## ADDENDUM TO THE CONTRACT

### JNU SREF Site Infrastructure

Contract No. E12-280

**ADDENDUM NO.:** ONE

WATER PLAN & PROFILE

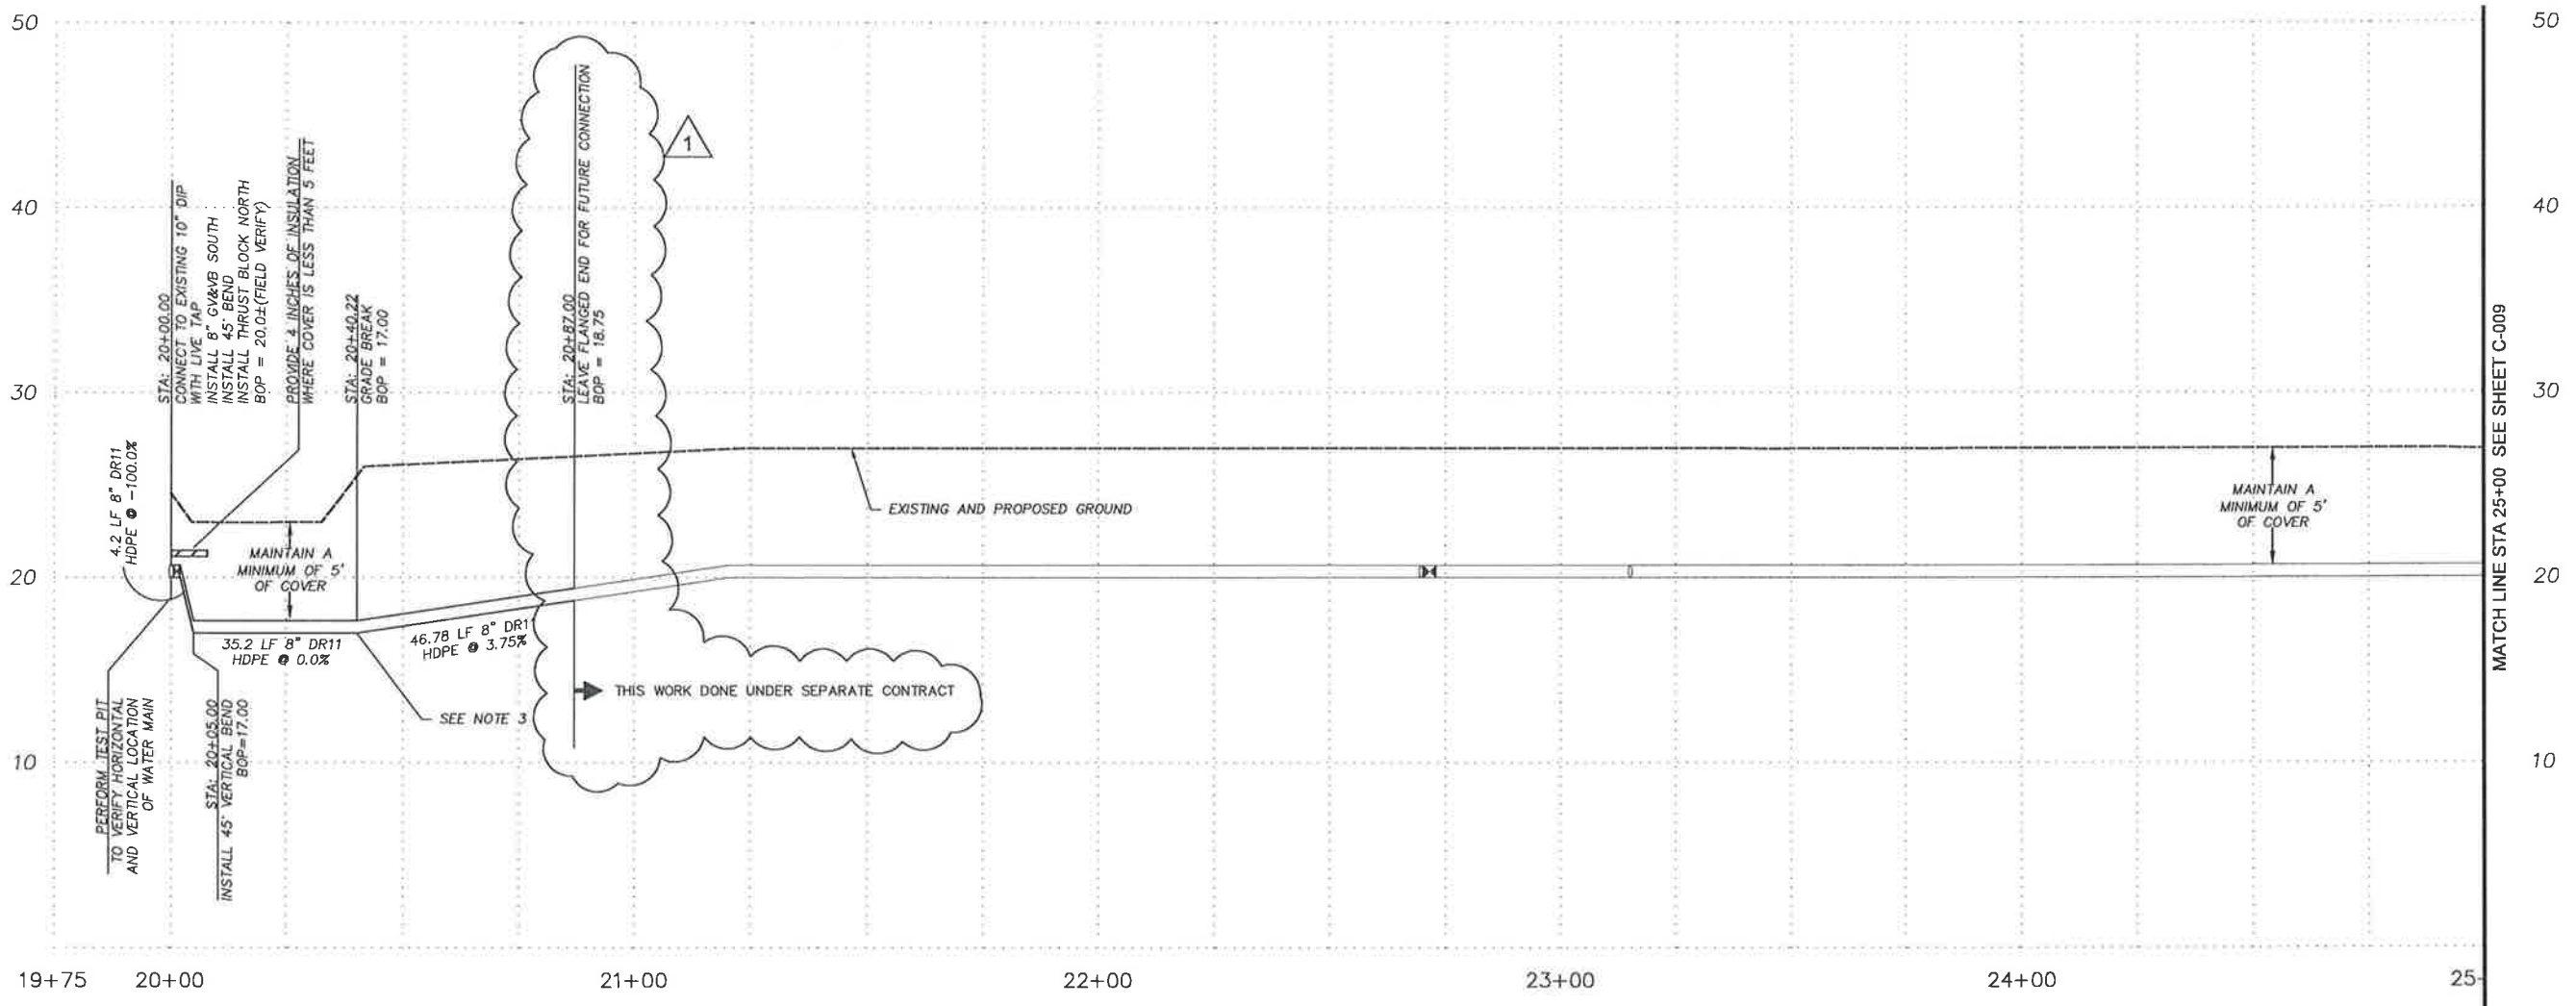
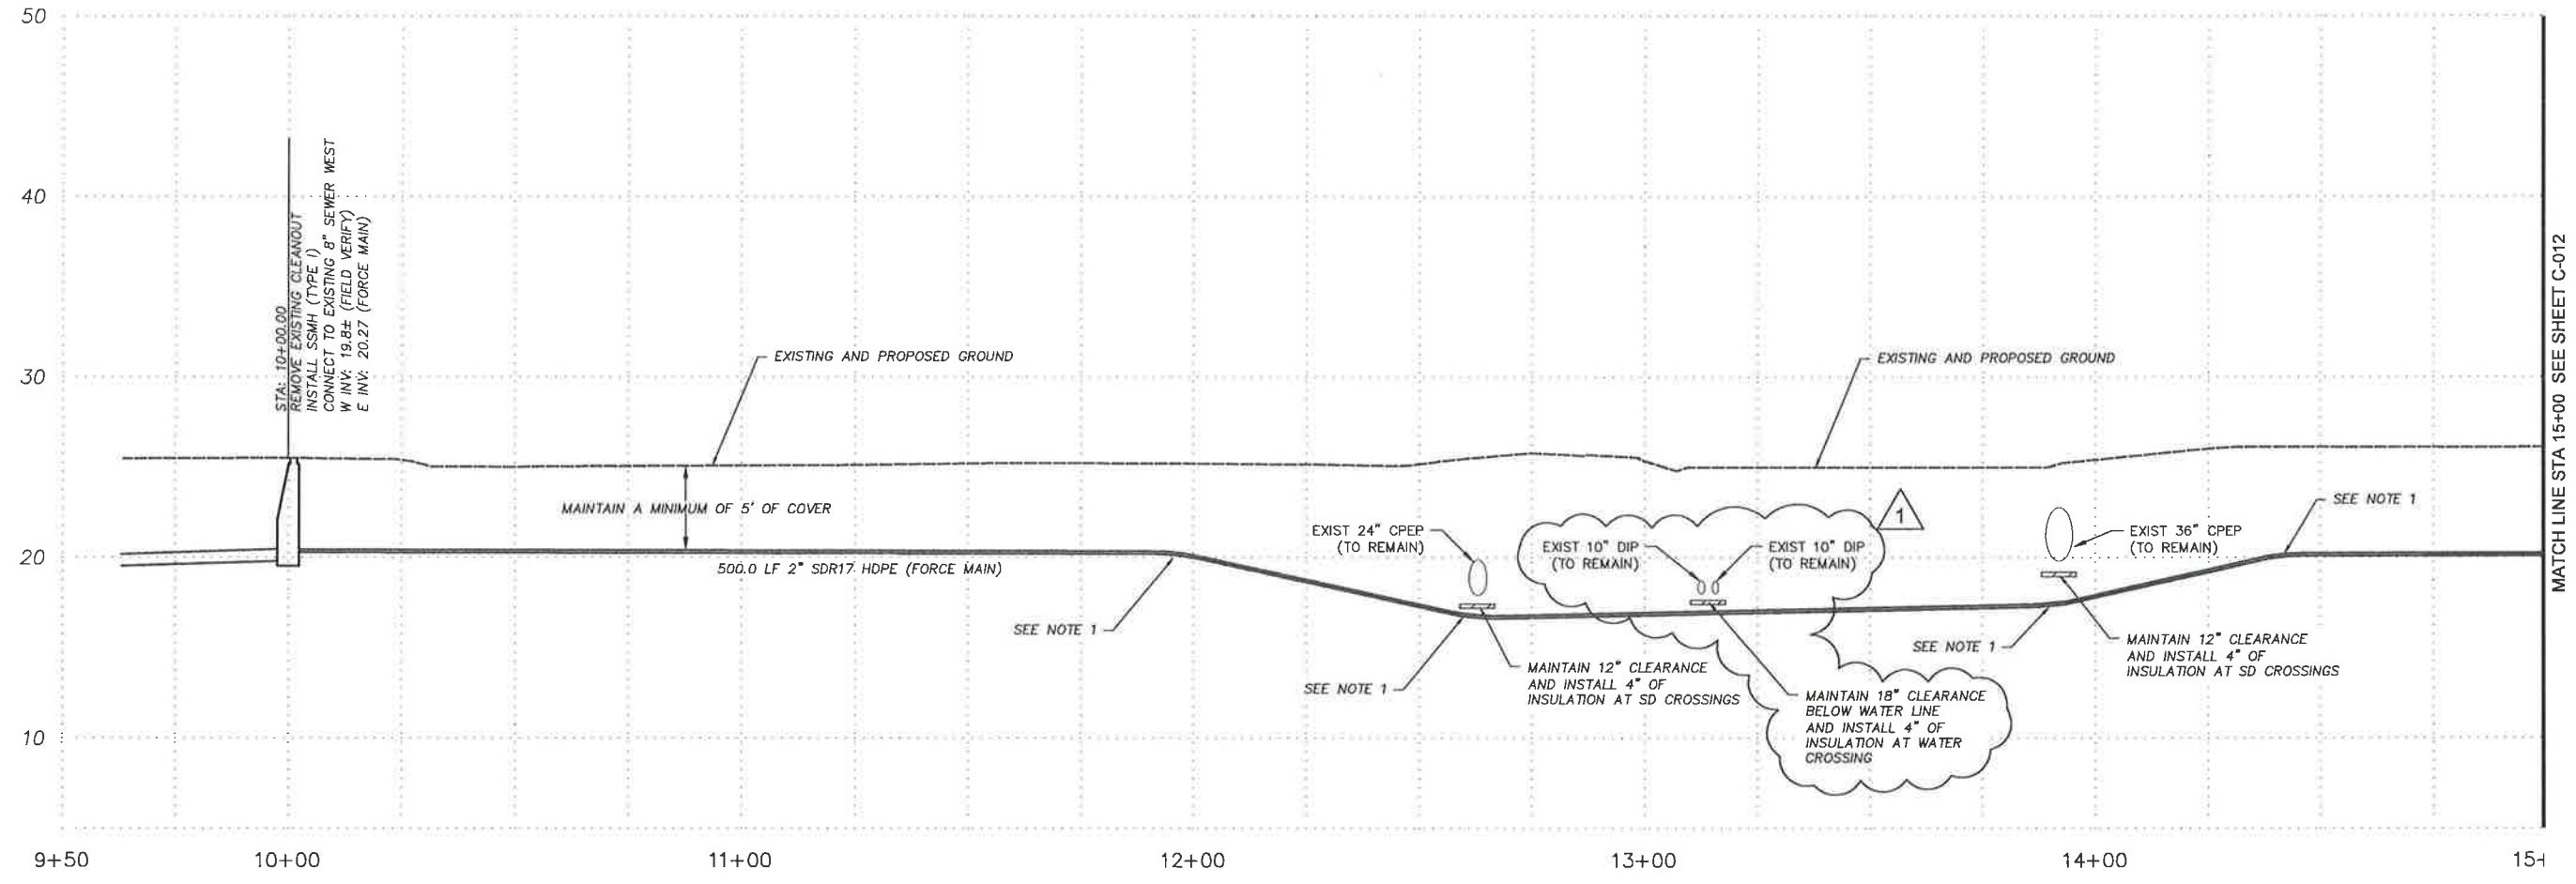
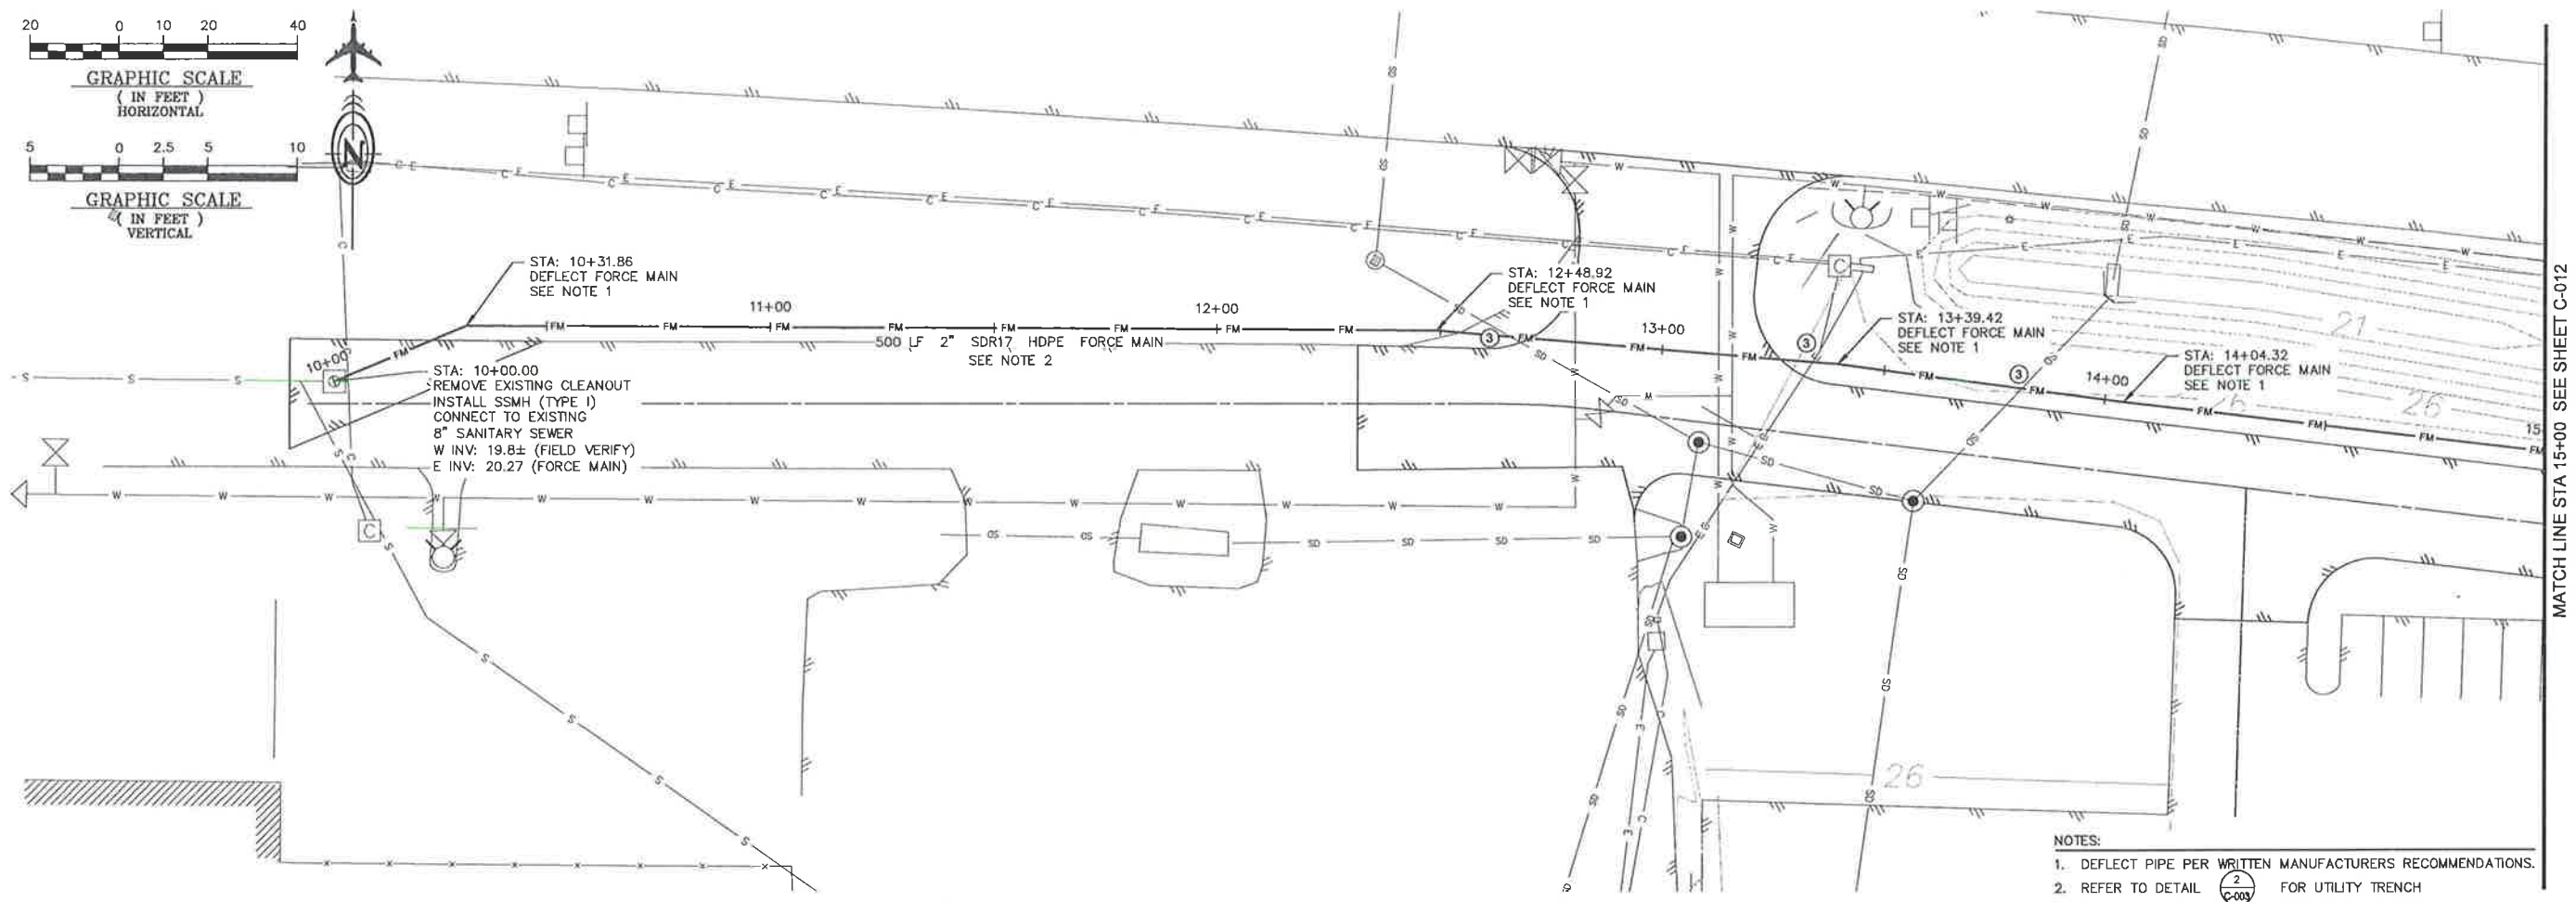
- Item No. 5: Drawing C-008, titled “Water Plan & Profile”, **replace** with the attached sheet: C-008, titled “Water Plan & Profile” Addendum 1  
Principal Changes:  
➤ Reduced length of waterline installed in this project to keep construction outside the airport perimeter fence.  
➤ Added that waterline shall be terminated with flange for future connection.

C-009

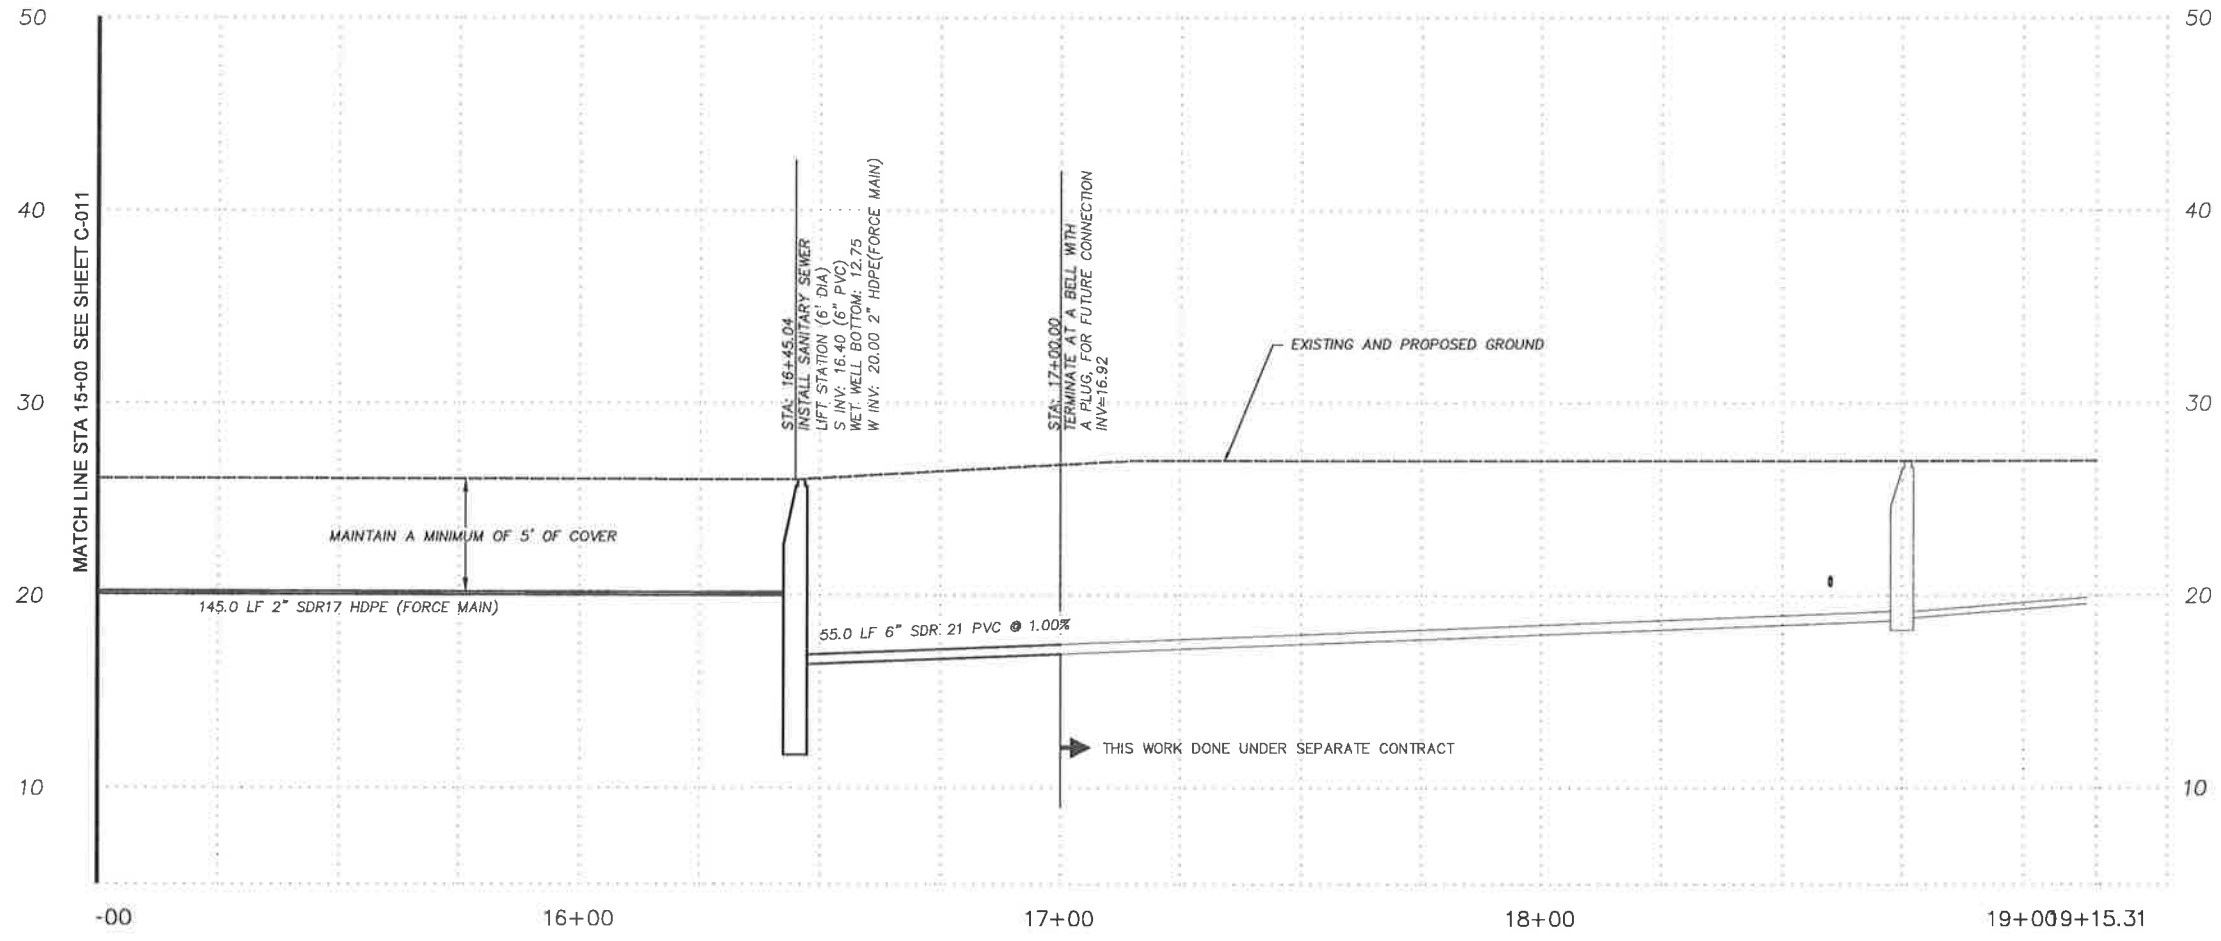
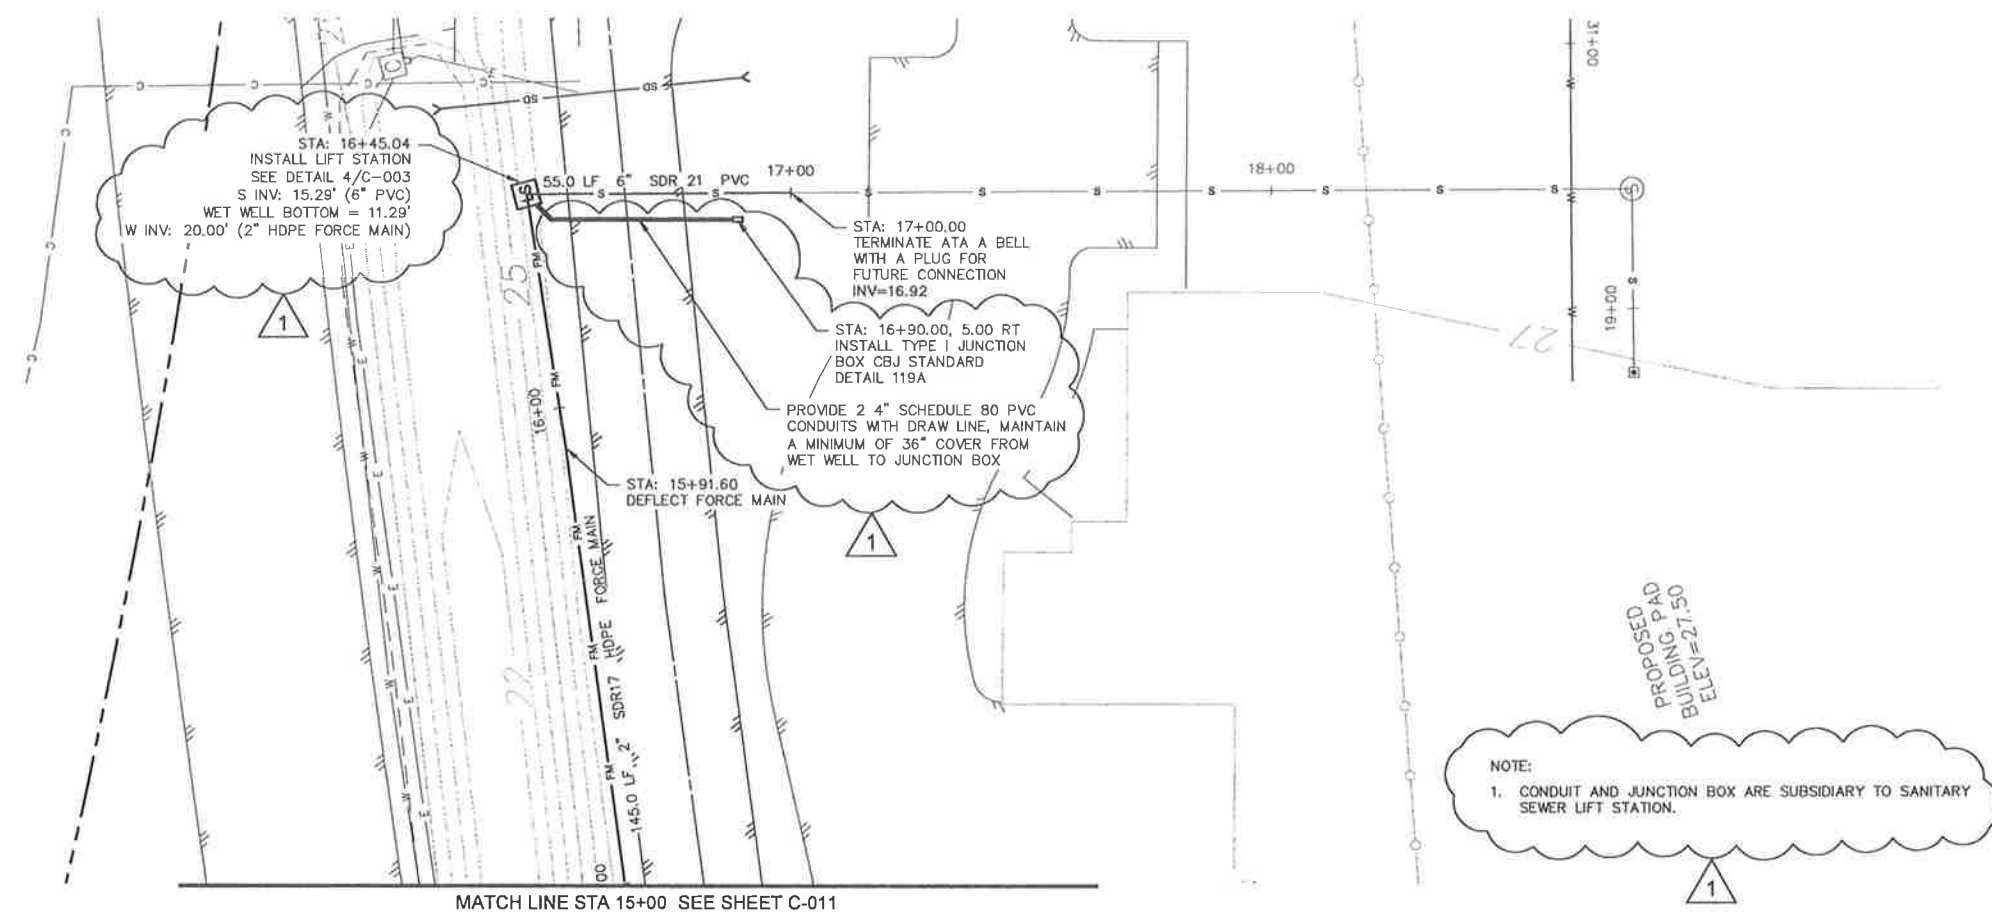
- Item No. 6: Drawing C-009, titled “Sewer Plan & Profile”, **replace** with the attached sheet: C-009, titled “Sewer Plan & Profile” Addendum 1  
Principal Changes:  
➤ Added information showing new waterline location (installed by others) and separation requirements for the installation of the sewer pipe.
